BID/ RFP ADDENDUM No.2
DATE: 08/16/2023
BID/RFP No: 2022-19
BID NAME: Vocational Building Remodel

ADDENDUM NO. 02

CAREER TECHNICAL EDUCATION BUILDING RENOVATION
Merced, CA

The following additions, deletions, and revisions to the SHEETS and Project Manual are hereby made and do become a part of these Contract Documents.

BUILDING
DEMOLITION FLOOR PLAN - FIRST FLOOR

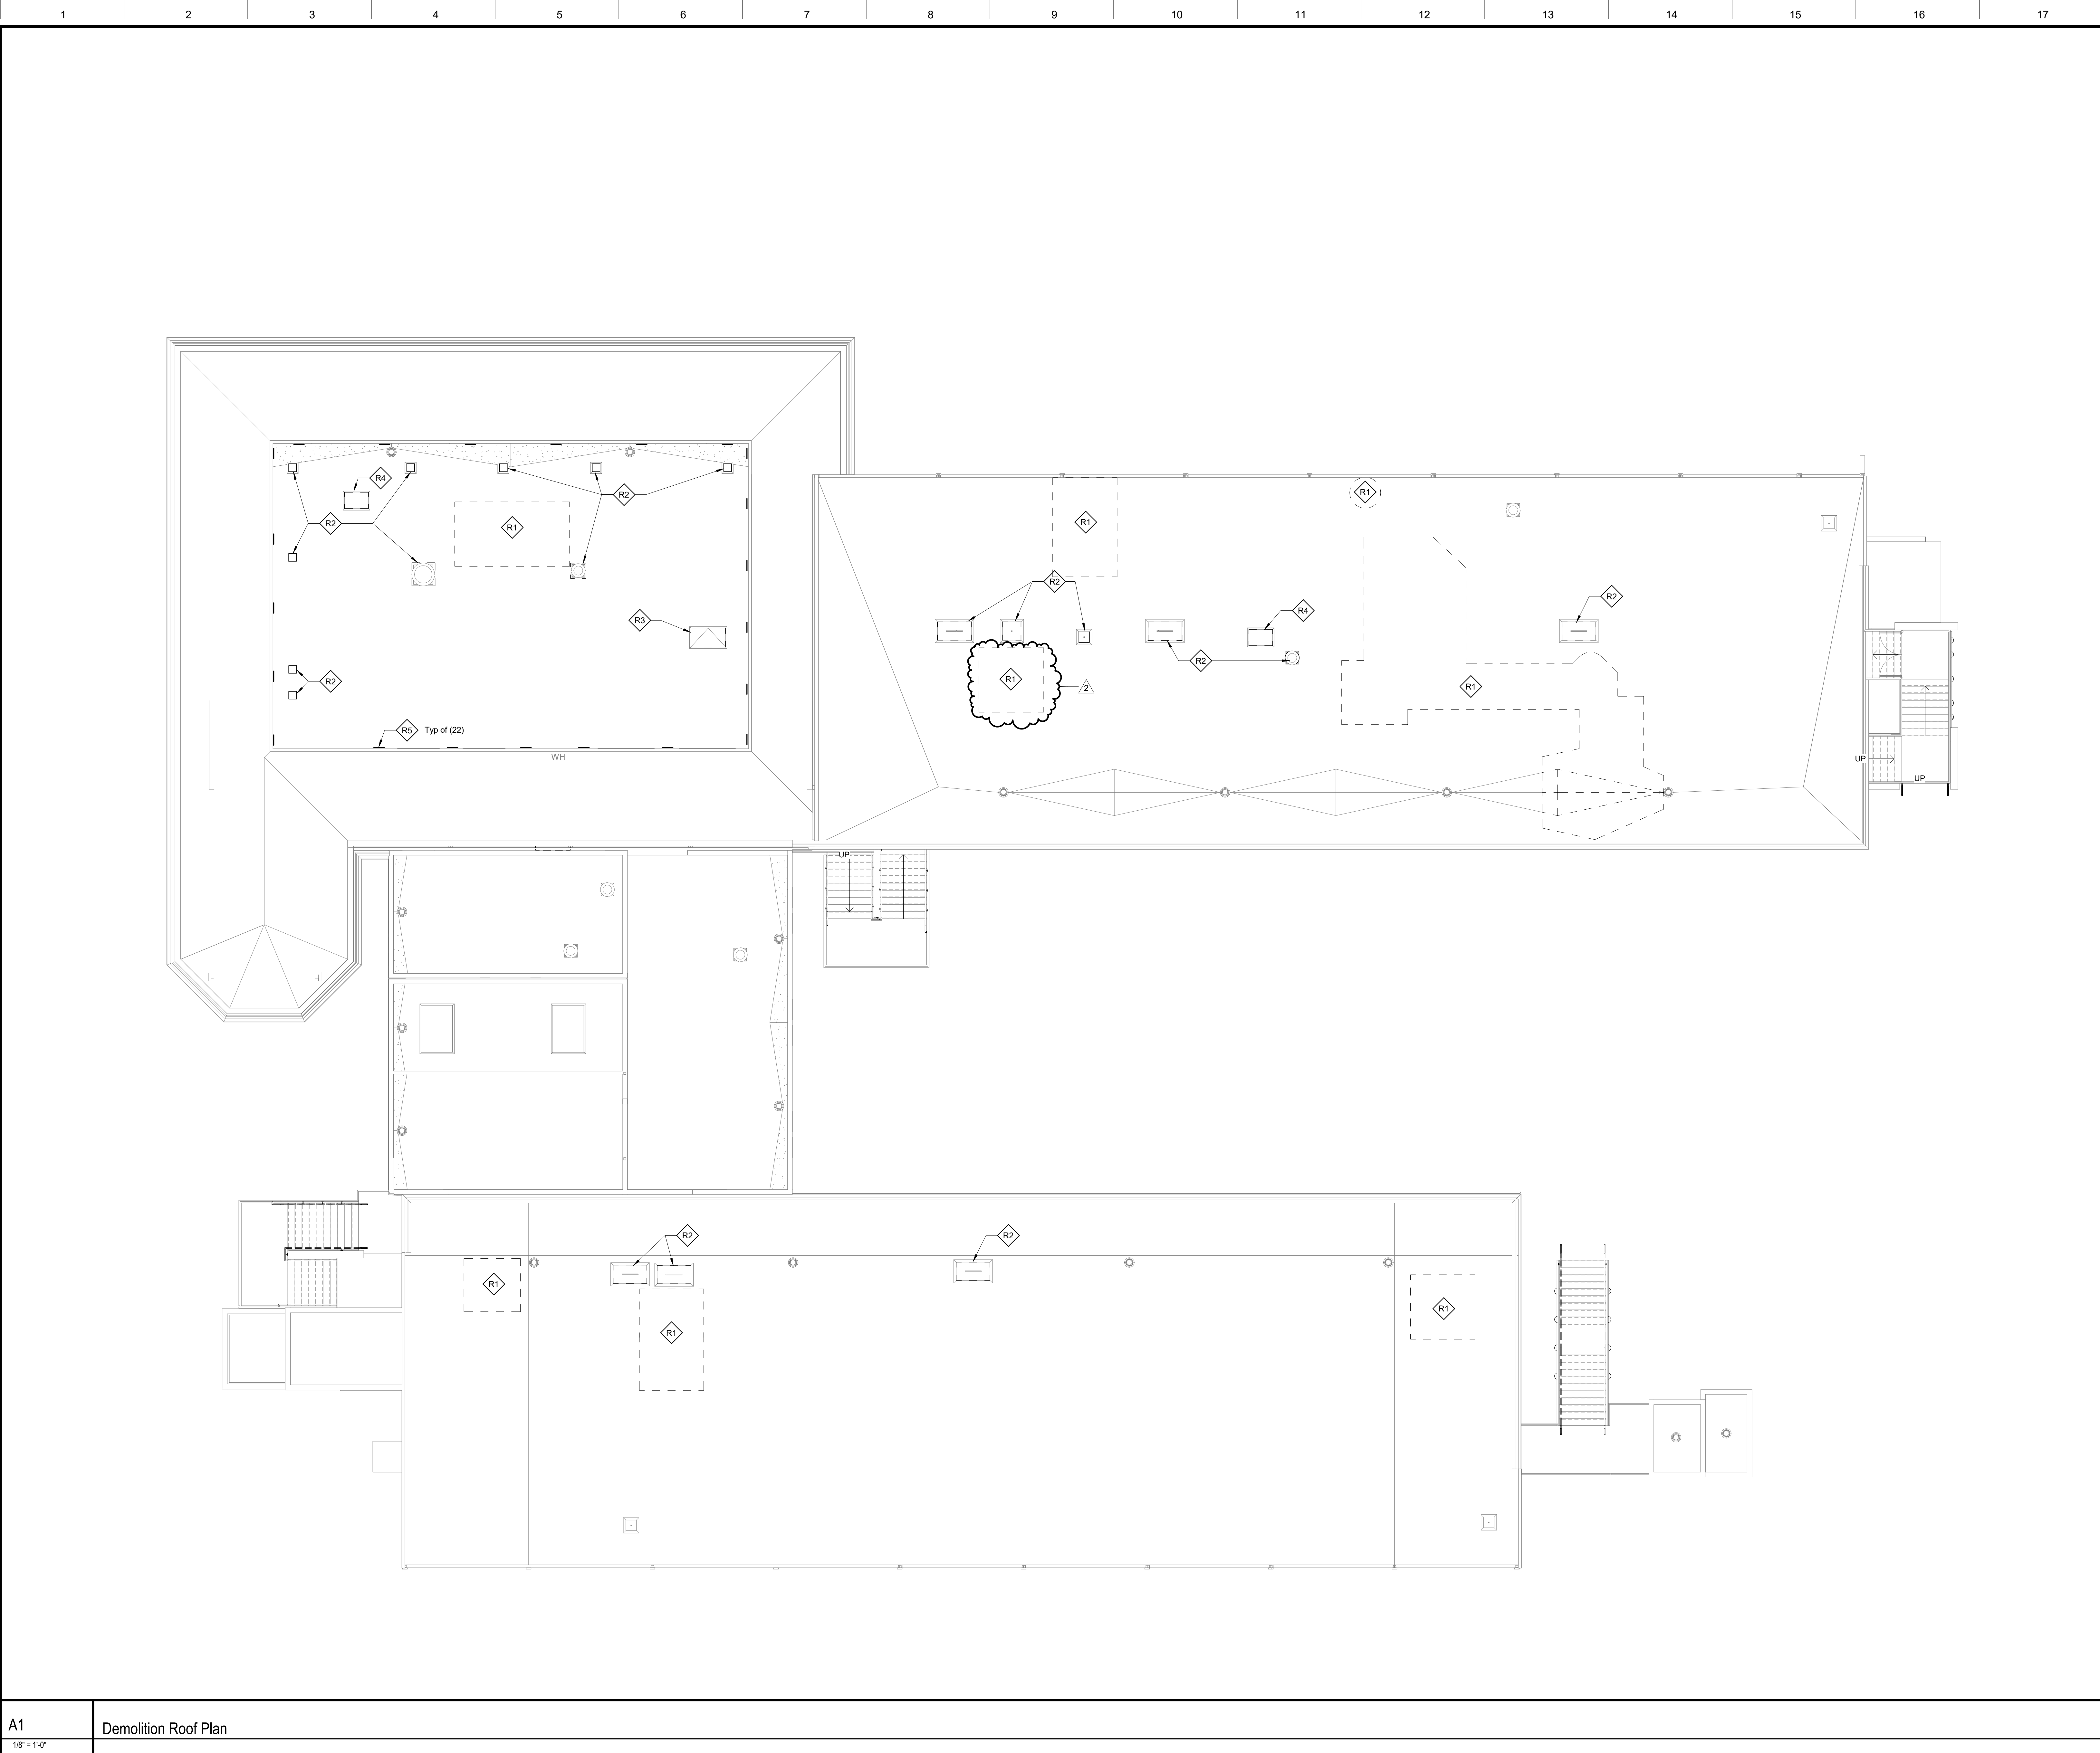
AD2-A03 Refer to Sheet A/A001, DEMOLITION FLOOR PLAN – FIRST FLOOR:

2. Replace sheet with attached sheet A/A001, DEMOLITION FLOOR PLAN – FIRST FLOOR with AD2-AX03 in the lower right corner. Changes are in the clouded area(s).

DEMOLITION ROOF PLAN

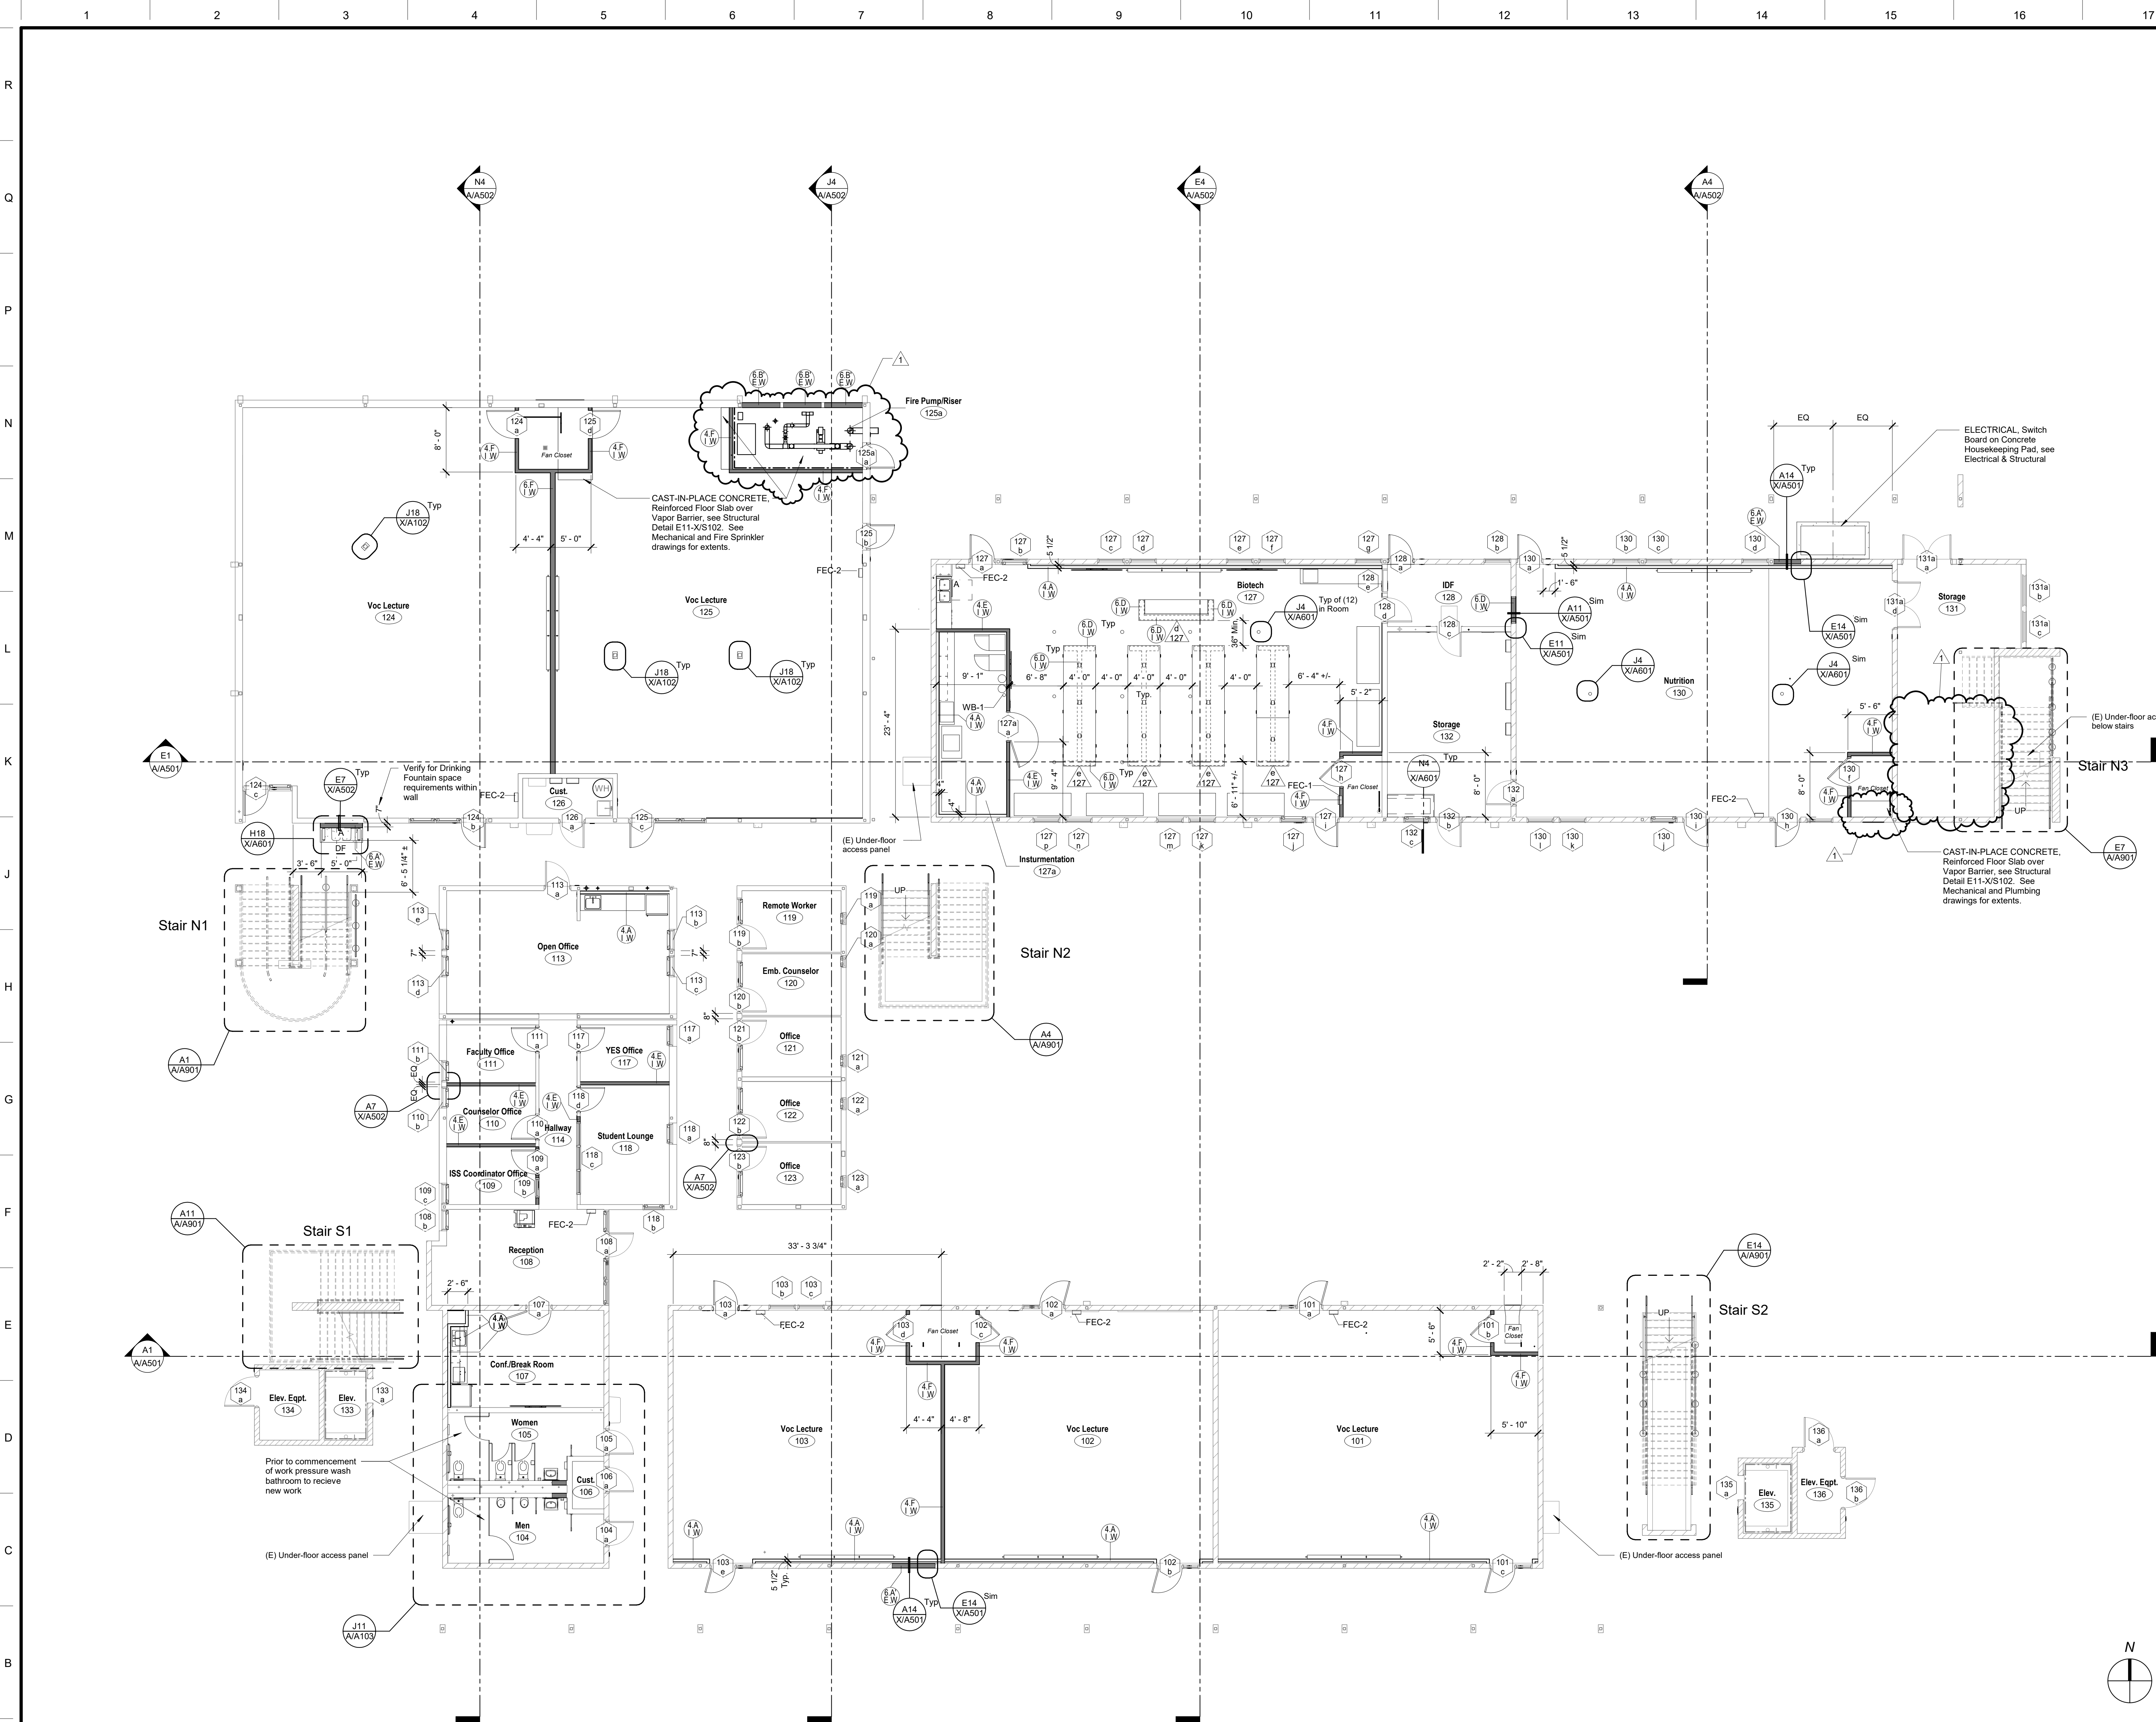
AD2-A05 Refer to Sheet A/A005, DEMOLITION ROOF PLAN:

1. Replace sheet with attached sheet A/A005 DEMOLITION ROOF PLAN with AD2-AX05 in the lower right corner. Changes are in the clouded area(s).

BUILDING
FLOOR PLAN - FIRST FLOOR

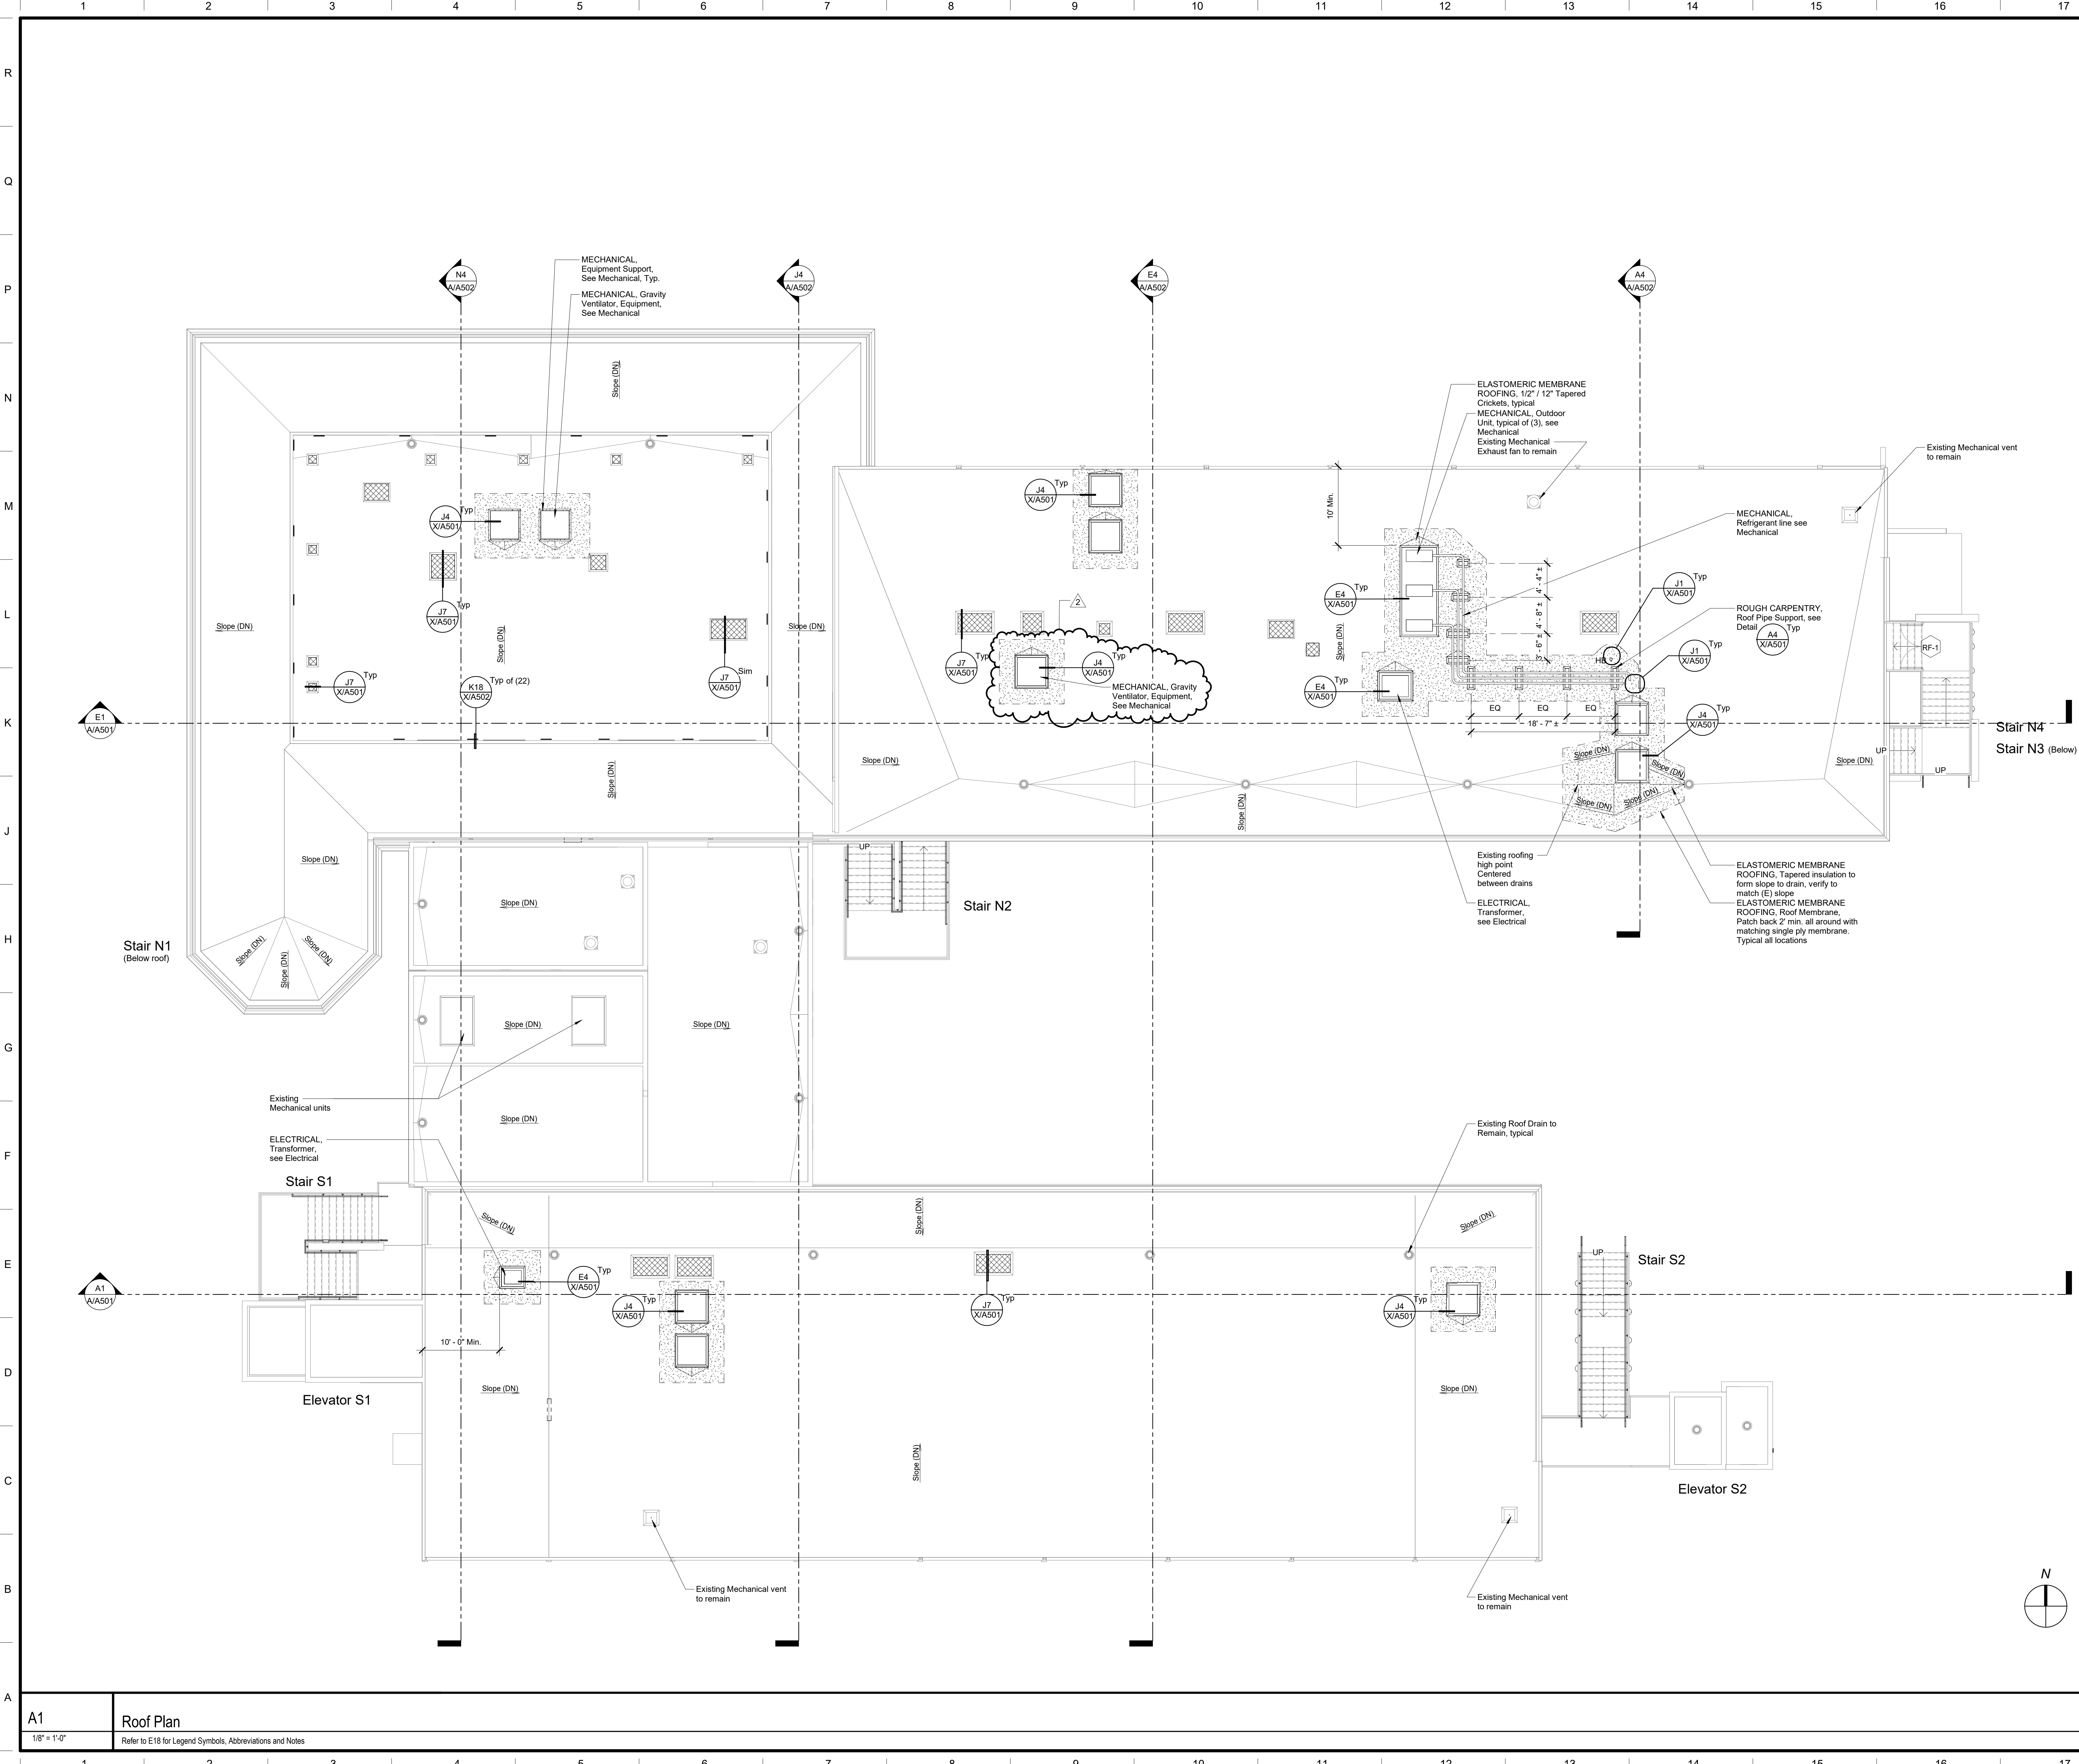
AD2-A06 Refer to Sheet A/A101, FLOOR PLAN – FIRST FLOOR:

1. Replace sheet with attached sheet A/A101 FLOOR PLAN – FIRST FLOOR with AD2-AX06 in the lower right corner. Changes are in the clouded area(s).
